HAND AMENDMENTS/CHANGES TO VFR CHARTS

MEF VALUE 37 & SPOT HEIGHT 3314FT

HAND AMENDMENT CHANGE TO VFR CHART LOCATION

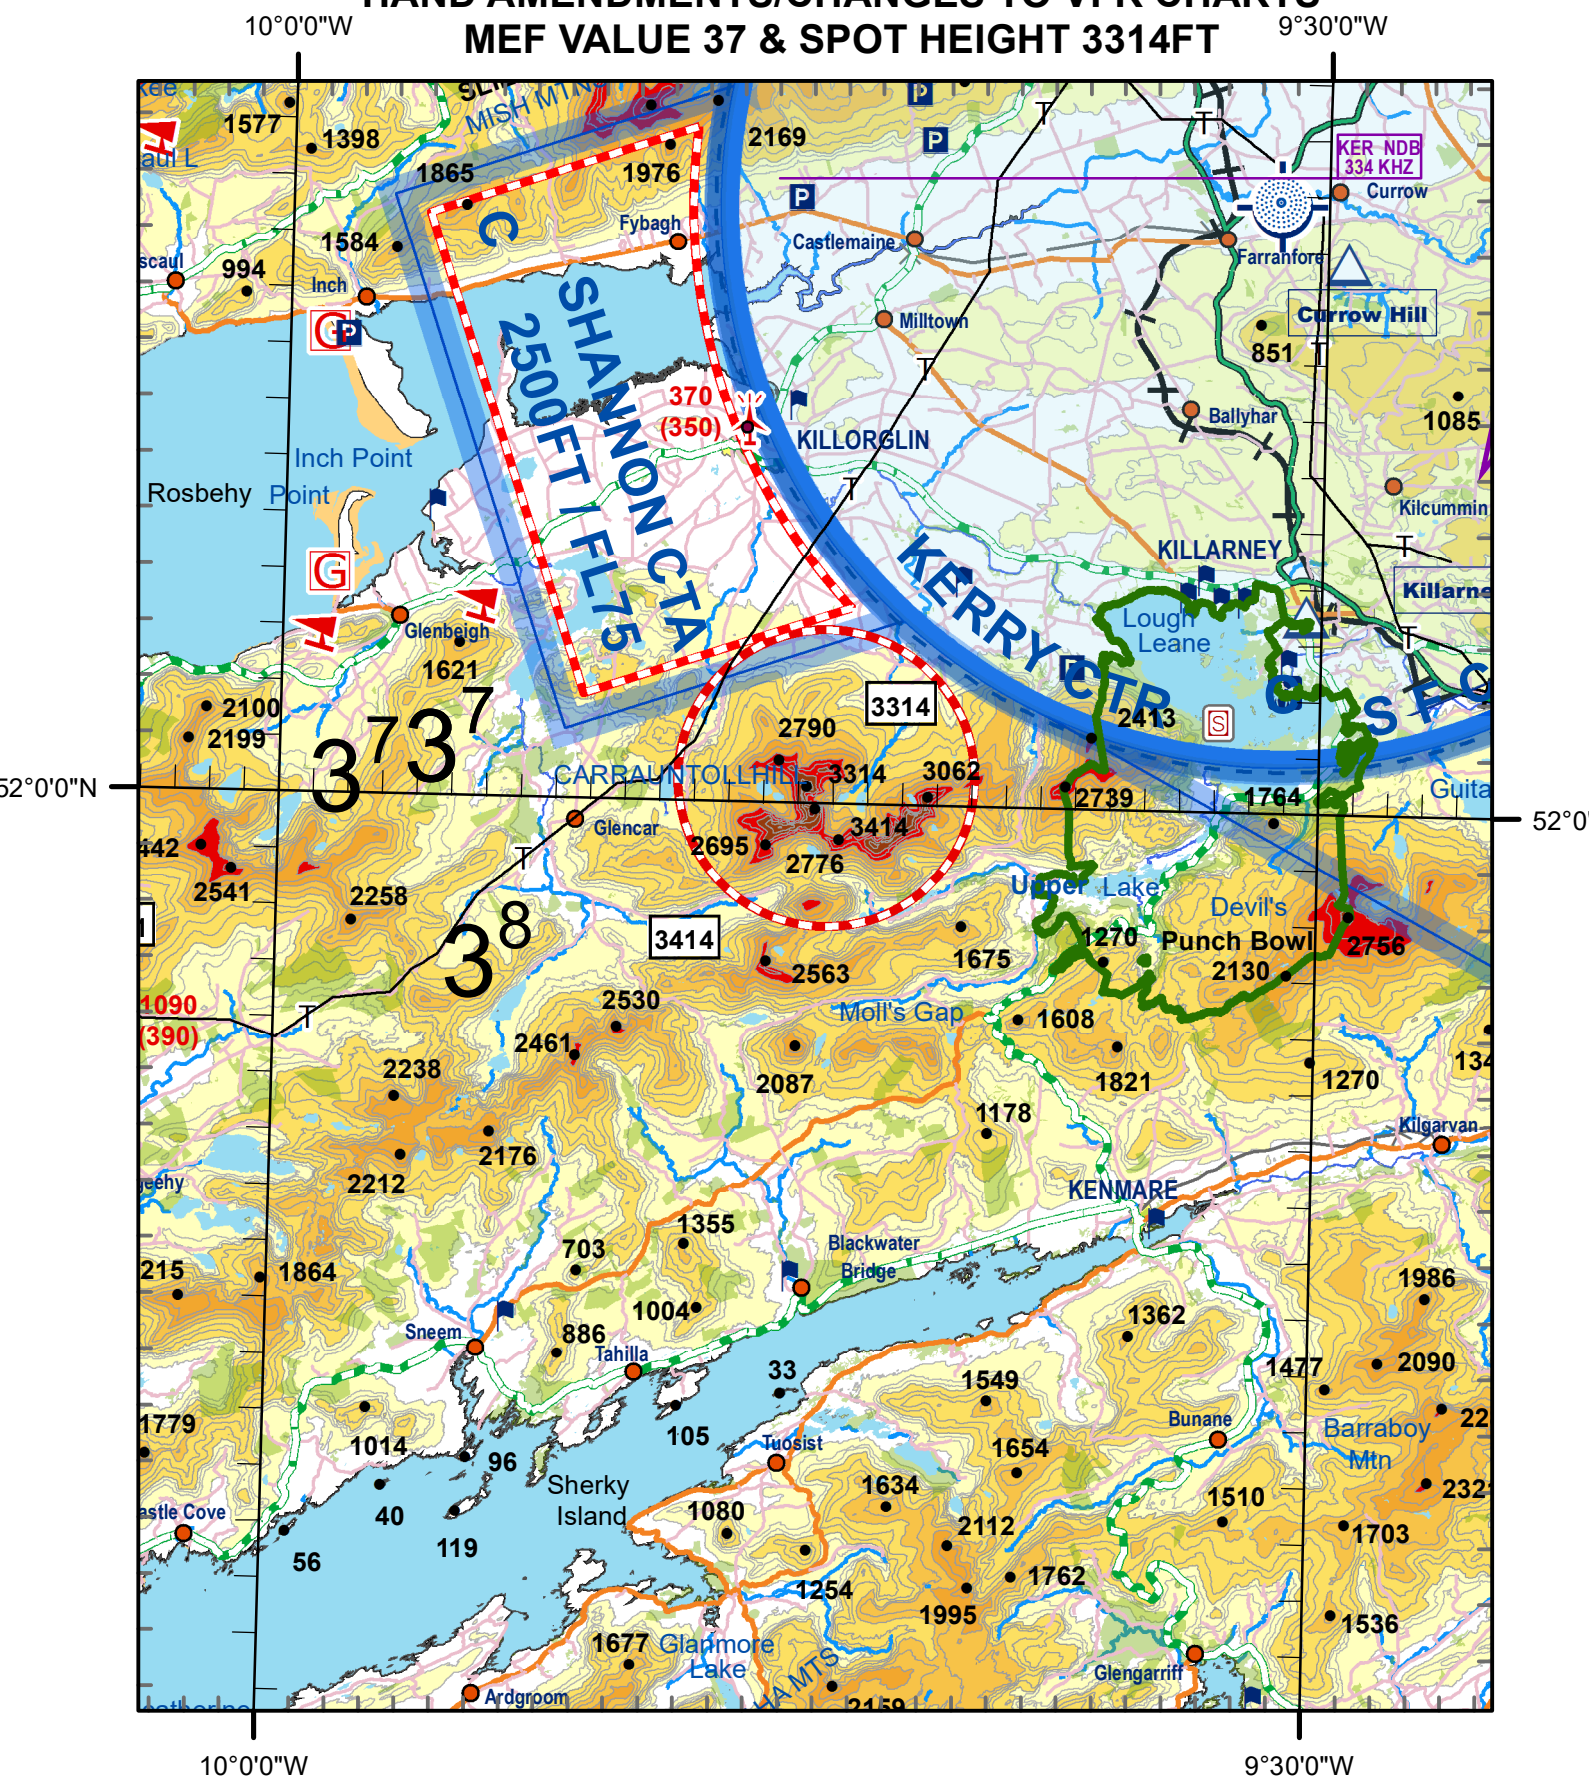
As a result of spot height 3314FT, the MEF Value 34 (3400ft) at 52000N 010000W Quadrant has been amended to 37 (3700ft).

Hand amendments need to be made to the following charts:

Aeronautical Chart 1:500,000

Aeronautical Chart/South 1:250,000
